Re: Environmental Stewardship Comments on GMA-12 Proposed Desired Future Conditions

Proposed Desired Future Condition(s) for Aquifer(s) in GMA 12

Environmental Stewardship

Submitted October 28, 2020

Figure 1. Predicted reduction of discharge of groundwater into the mainstream Colorado River due to combined pumping (Old GAM).

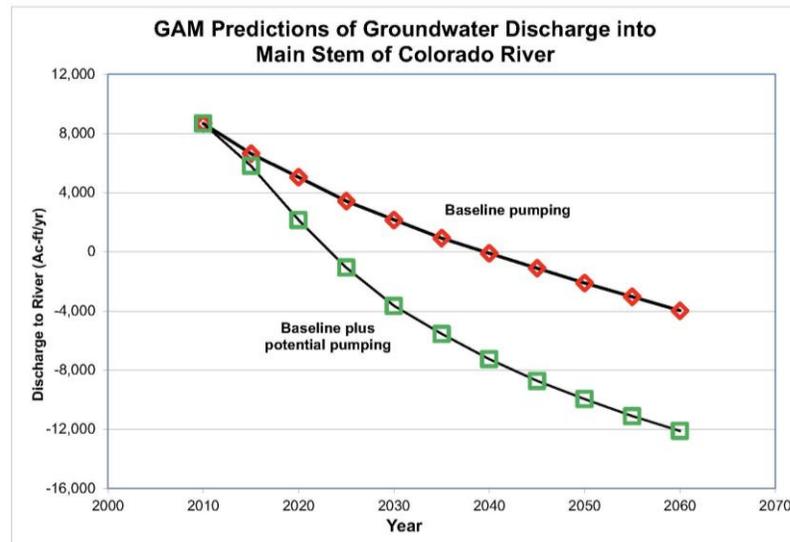
Figure 1 represents the predicted discharge of groundwater into the main stem of the Colorado River for **baseline** pumping (which later became the adopted 2017 DFCs) and **baseline plus potential pumping** (now permitted pumping) using the Old GAM.

- The Old GAM predicted that **baseline** pumping will:
 - Reduce discharge to the main stem of the Colorado River by about 13,000 ac-ft per year from 2010 to 2060.

- Reverse its historical relationship to the aquifers by changing from a stream that *gains* water from the aquifers (a gaining stream) to a stream that *loses* water to the aquifers (a losing stream) in about 2040.

- The Old GAM predicted that **potential pumping** by Vista Ridge, End Op (now Recharge Water) Forestar and LCRA power plant will:
 - Reduce discharge to the main stem of the Colorado River by about 22,000 ac-ft per year from 2010 to 2060.

- Reverse its historical relationship to the aquifers by changing from a stream that *gains* water from the aquifers (a gaining stream) to a stream that *loses* water to the aquifers (a losing stream) about 20 years earlier (2020) than baseline pumping.

Figure 2. Predicted reduction of discharge of groundwater into the mainstream Colorado River due to DFC Run 3 and Scenario S-7 (New GAM).

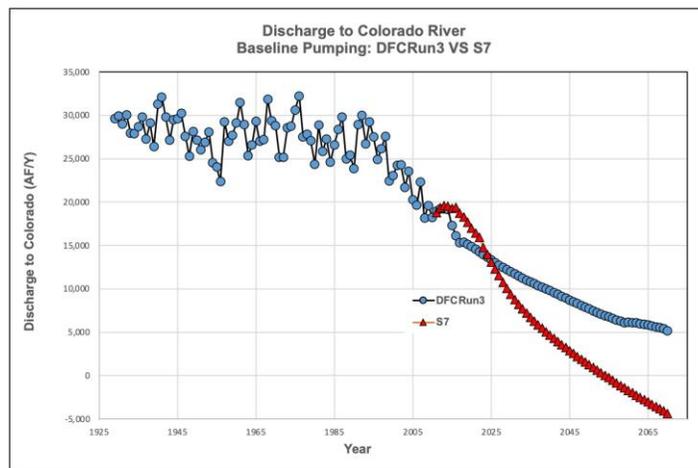
Figure 2 represents the predicted discharge of groundwater into the main stem of the Colorado River for **DFC Run 3** pumping (blue line) and **Scenario S-7** pumping (red line) using the New GAM.

- The New GAM (**DFC Run 3**) predicts that pumping will:
 - Reduce discharge to the main stem of the Colorado River by about 14,000 ac-ft per year from 2010 to 2070.

- The New GAM (**S-7**) predicts that pumping will:
 - Reduce discharge to the main stem of the Colorado River by about 24,000 ac-ft per year from 2010 to 2070.

- Reverse its historical relationship to the aquifers by changing from a stream that *gains* water from the aquifers (a gaining stream) to a stream that *loses* water to the aquifers (a losing stream) by about 2050.

- **By comparison:**
 - The new GAM predicts that **Scenario S-7** will reduce outflows by about 10,000 ac-ft per year more than **DFC Run 3**.
 - The new GAM predicts that **Scenario S-7** will cause a reversal in the surface water-groundwater relationship to occur about 2050 whereas **DFC Run 3** does not predict a reversal within the planning period.

Figure 3: Groundwater Discharge to four tributaries of the Colorado River located primarily in Bastrop County, TX (New GAM).

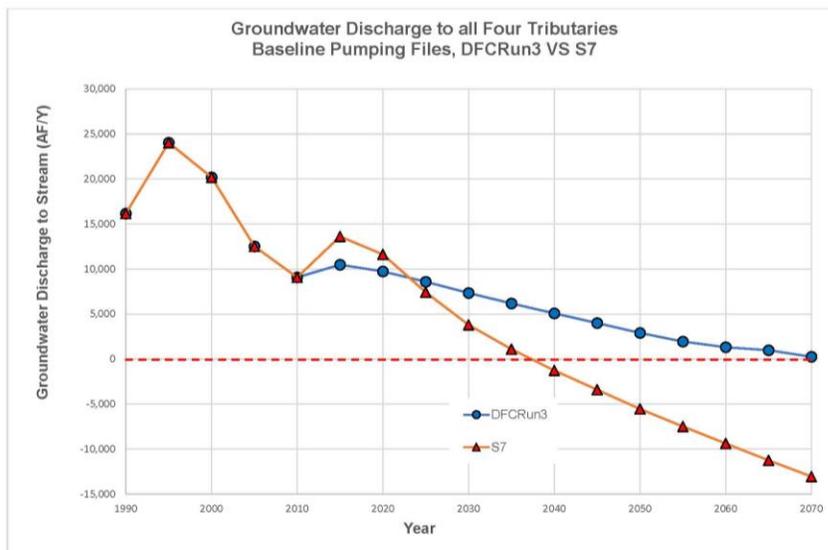
The new GAM predicts (Figure 3) that combined flows of the four tributaries:

- Have had historic outflows that were significantly higher than are predicted during development,
 - outflows declined during the early development period; and
 - outflows are predicted to continue to decline as pumping increases in the current development period.
- Will reverse their relationship with the aquifers by contributing surface waters to the aquifers (losing streams) during the planning period.
 - S-7 pumping will accelerate the reversal by several decades.

Figure 4. Groundwater Discharge to Wilbarger, Big Sandy, Walnut/Cedar and Piney Creeks/Lake Bastrop, Bastrop County, TX (New GAM).

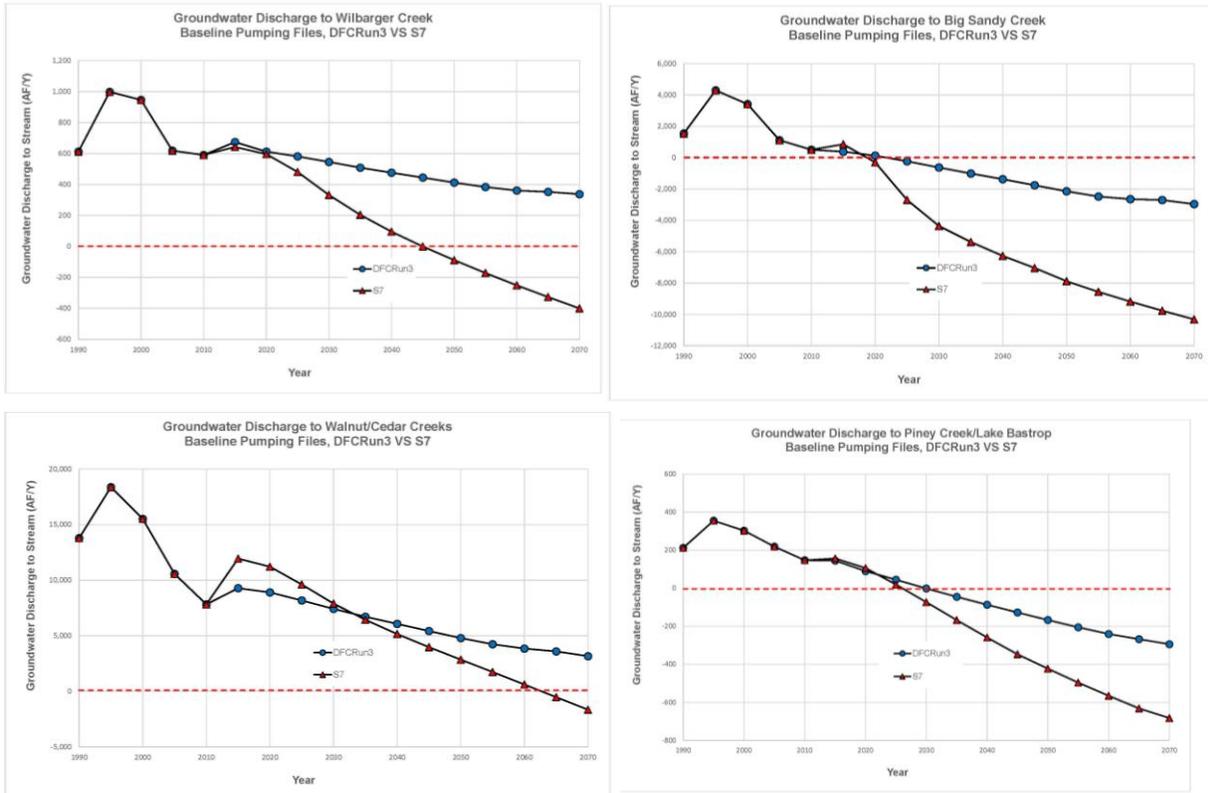
Wilbarger Creek: Overall, S-7 pumping caused a greater decline in outflows from the aquifers than DFC Run 3. Likewise, S-7 pumping is predicted to cause a reversal in the surface water-groundwater relationship whereas DFC Run 3 does not predict a reversal. Wilbarger Creek flows across the outcrops of the Hooper, and the Simsboro.

Big Sandy Creek: Overall, S-7 pumping caused a greater decline in outflows from the aquifers than DFC Run 3. Both DFC Run 3 and S-7 pumping predict a reversal in the surface water-groundwater relationship has already occurred. Big Sandy Creek flows across the outcrops of the Hooper, Simsboro, and Calvert Bluff.

Walnut/Cedar Creek: Overall, S-7 pumping caused a greater decline in outflows from the aquifers. Likewise, S-7 pumping is predicted to cause a reversal in the surface water-groundwater relationship whereas DFC Run 3 does not predict a reversal. Walnut/Cedar flows across the outcrops of the Hooper, Simsboro, Calvert Bluff, and Carrizo.

Piney Creek/Lake Bastrop: Overall, S-7 pumping caused a greater decline in outflows from the aquifers. Both S-7 pumping and DFC Run 3 are predicted to cause a reversal in the surface water-groundwater relationship. Piney Creek/Lake Bastrop flows across the outcrops of the Calvert Bluff and Carrizo.

Figure 6. Wilbarger creek Interaction with Aquifer, All Nodes 1990, 2020, 2050 and 2070 (New GAM).

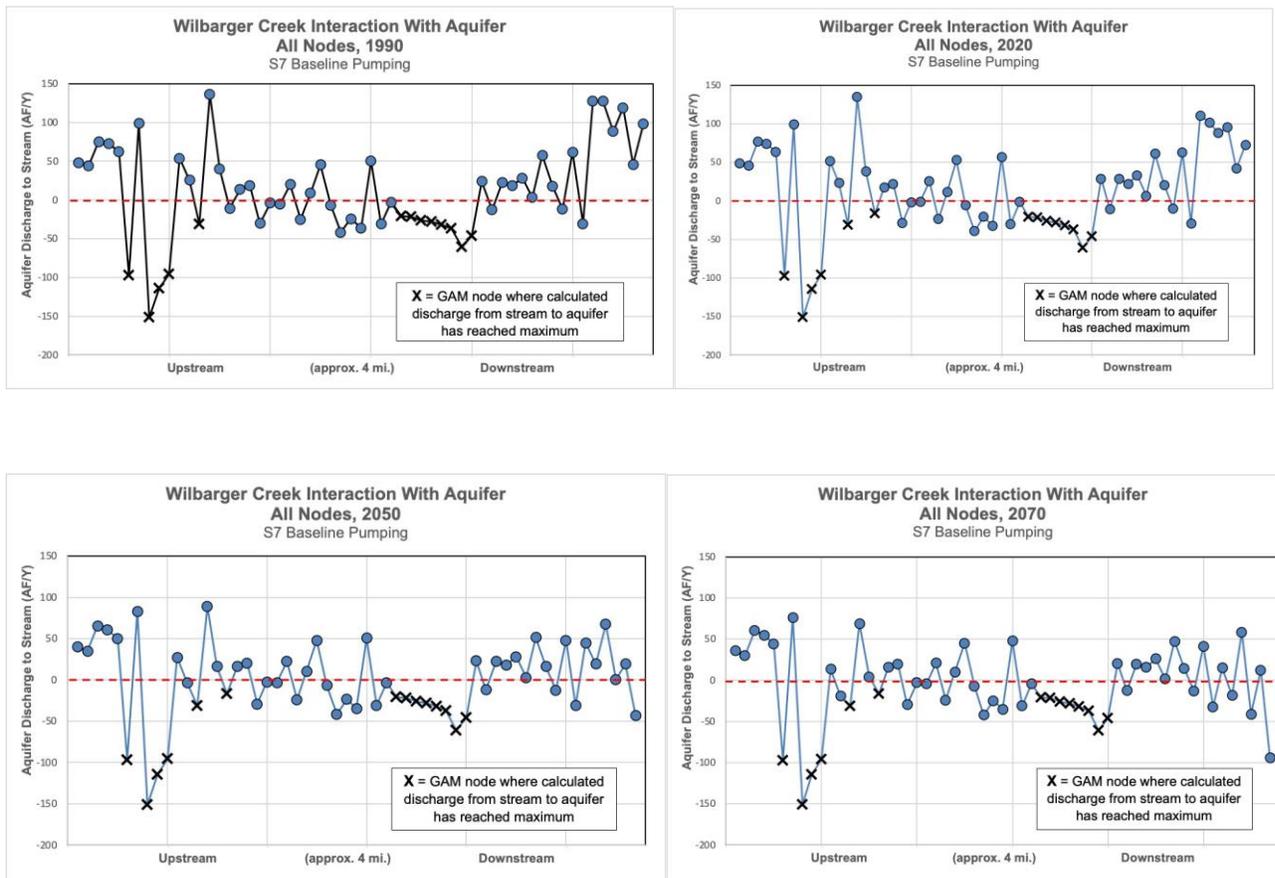
Figure 6 represents Wilbarger Creek's interaction with the Colorado River alluvium, and the Hooper and Simsboro formations of the Wilcox Group in the years 1990, 2020, 2050 and 2070.

The maximum discharge rate from Wilbarger Creek to the aquifers¹¹ occur at 14 nodes. These nodes are listed in Appendix 1. At 13 of the nodes the maximum rate is already occurring by the year 1990. This is because the head in the underlying aquifer is already below the bottom of the streambed. The exception is node 4615 (layer 2 Hooper) which begins discharging at the maximum rate by 2020.

The other finding from this analysis occurs in the last six nodes nearest the confluence of Wilbarger Creek with the Colorado River. There is a strong trend for outflows in this segment of the stream to decline from a high of 150 ac-ft per year in 1990 (a gaining stream) to a low of minus 100 ac-ft per year in 2070 (a losing stream).

Figure 8. Colorado River at Bastrop gage during drought period Jan. 2011 - Dec. 2013. A hydrograph separation is requested for the period.

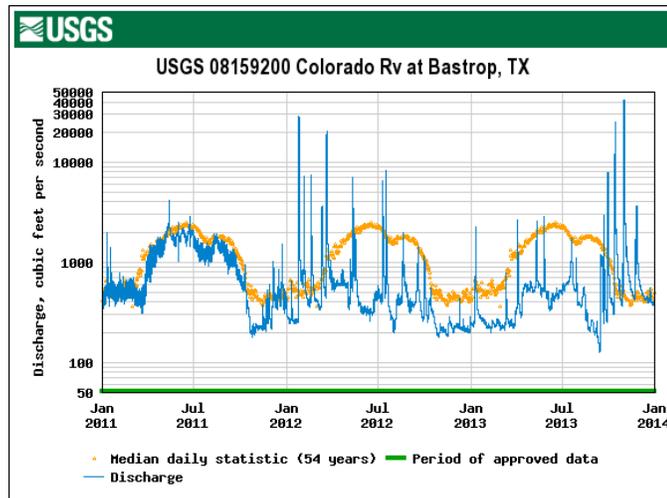
Figure 8 is a hydrograph of the three year drought period from January 2011 through December 2013 when the region experienced some of the most severe drought conditions in decades. The distinguishing feature of this figure is that in-stream flows benefitted from the irrigation releases for down-stream rice farming during the spring, summer and early fall of 2011 and then was curtailed during the 2012 and 2013 irrigation seasons. There was very little flow from rainfall during the 2011 period. Lacking irrigation flows, flow in the river for the summer and fall would likely have dropped below the subsistence environmental flow range during that period. The health of aquatic communities in the Colorado River cannot be dependent on such calls by downstream water rights holders, demonstrating the need to protect and preserve groundwater inflows to the maximum degree possible.

A hydrograph separation on the three year period represented in Figure 8, with irrigation releases and return-flows accounted for, would likely reveal a very good estimate of actual groundwater outflows to the river from the Carrizo-Wilcox Aquifer group. During this period the bank storage for the river had likely been exhausted and the river was relying on the minimum flows passing through the Austin gage at Longhorn Dam, City of Austin, Pflugerville and Elgin return flows, and groundwater baseflows.

TCEQ InSTREAM PROGRAM ANALYSIS OF HYDROGRAPHS MEASURED AT RIVER GAUGES

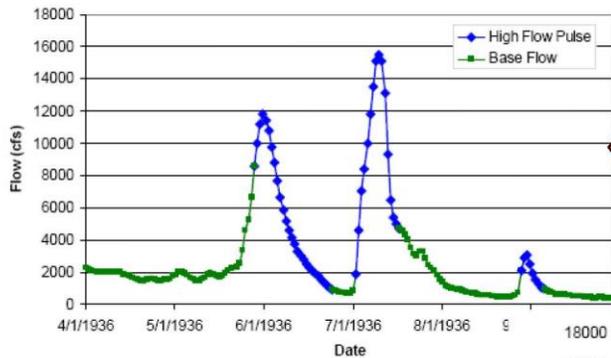
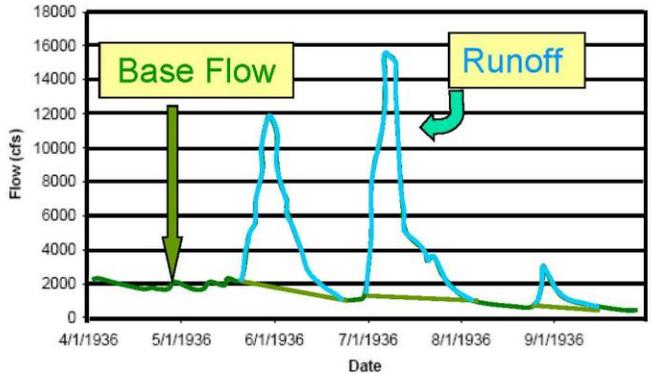
Slide 27 of the GMA Consultant Team's presentation discussed hydrograph separation of river gage data to separate a hydrograph into groundwater discharge and runoff components.
